Change Order

PROJECT: (Name and address) Hopkins County New Board Office 2135 North Main Street

Change Order Number: 003

THE CONTRACT IS CHANGED AS FOLLOWS:

RFI Under Slab Plumbing Sketch.pdf (0.43 MB)

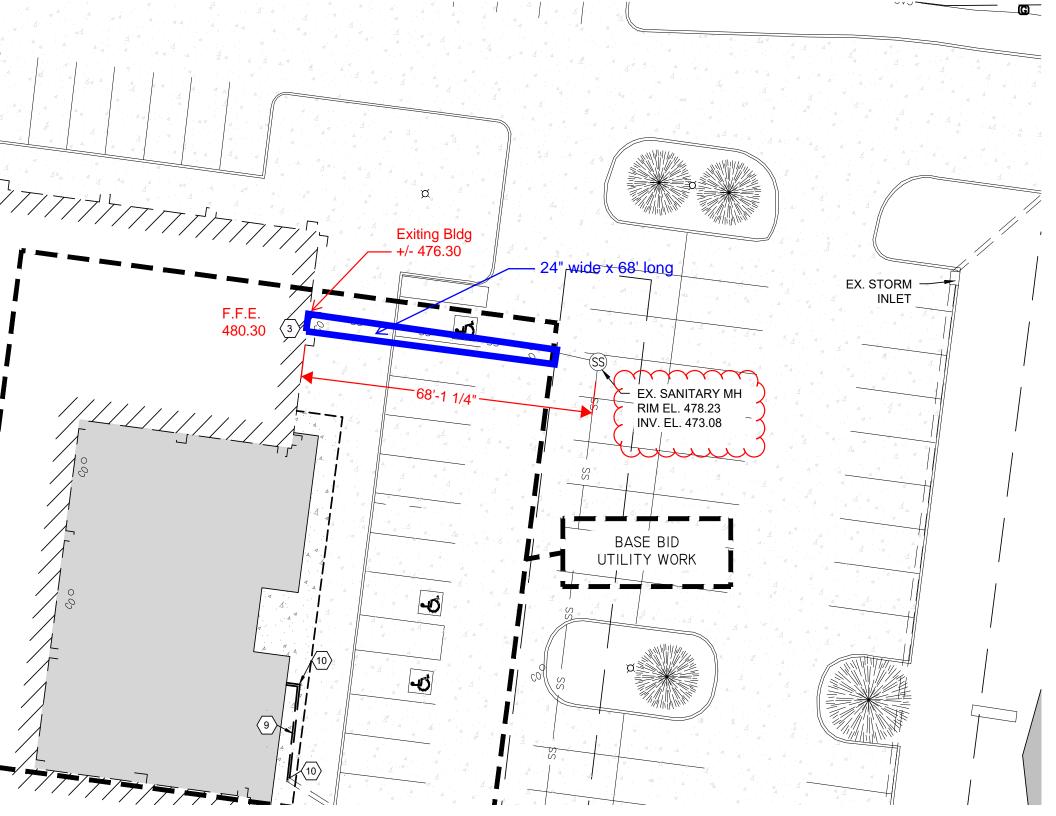
RFI Question: As shown on the prints and the plumbers have located the existing exterior sewer pipe where it enters the building, the sewer line is 34" deep. While calculating the depth the plumbers need using minimal slope, it appears the sanitary drainpipe will be exiting the building at a depth of 46" to 48" - this will not work. The sewer extends toward a manhole farther out on the property, but the plumber is unsure of the depth. Please advise on how to proceed.

RFI Response From Design Team: Based on survey information the manhole referred to in the question above should have sufficient depth. There is also an intermediate cleanout as shown on the attached sketch that could possibly have sufficient depth as well. Contractor verify depth of the intermediate cleanout and the manhole. If connection can be made at the intermediate cleanout or before, extend the new lateral and make connection at the existing lateral where sufficient depth provides. If the lateral must be extended to the manhole and the existing lateral invert is deep enough connection can be made at the existing lateral. If the existing lateral is not deep enough, verify no other lines are connected to the existing lateral and cut and cap at the manhole. Core new manhole connection and extend new lateral from building cleanout to the manhole. New connection to be made using kor-n-seal or equivalent. Contractor, please provide cost for above scenarios including restoration of exiting disturbed surfaces.

HOPCOBE-PLANU1.1.pdf.pdf (0.61 MB)

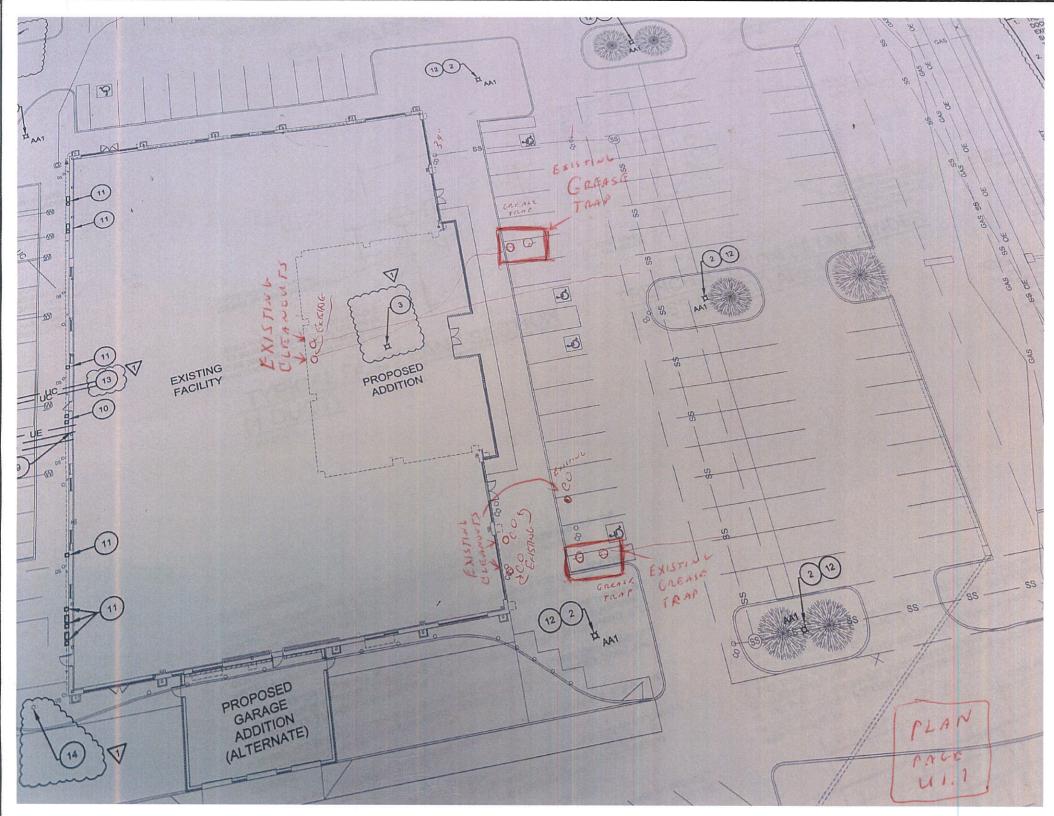
RFI Question: Upon investigation of the existing plumbing system, the subcontract has discovered two existing grease traps on the exterior of the building (see attached drawing). One grease trap is outside the area of the new addition with sanitary & grease line piping running underneath the new addition and exterior cleanouts brought to ground level. The second grease line is located outside the existing building with exterior cleanouts in both the sanitary and grease lines. Is all existing piping to be removed within the confines of the existing building and the new addition to be capped off outside the building? Or are they to be capped off wherever the plumber crosses the lines in the interior?

RFI Response From Design Team: Interior piping shall be cut to allow new pipe installation. In said areas the existing shall be capped in place. Civil should reply to exterior structures. BFW RESPONSE: 1. If able to access the outlet to the grease trap from the inside, place the plug in the effluent line and fill the grease trap and existing lines with flowable fill. 2. If unable to access the effluent of the tank from the inside, the effluent line will need to be excavated at the outlet of the tank, cut, and cap the existing effluent line, fill grease traps and existing lines under the building with flowable fill. Backfill and compact excavation and patch the Asphalt surface
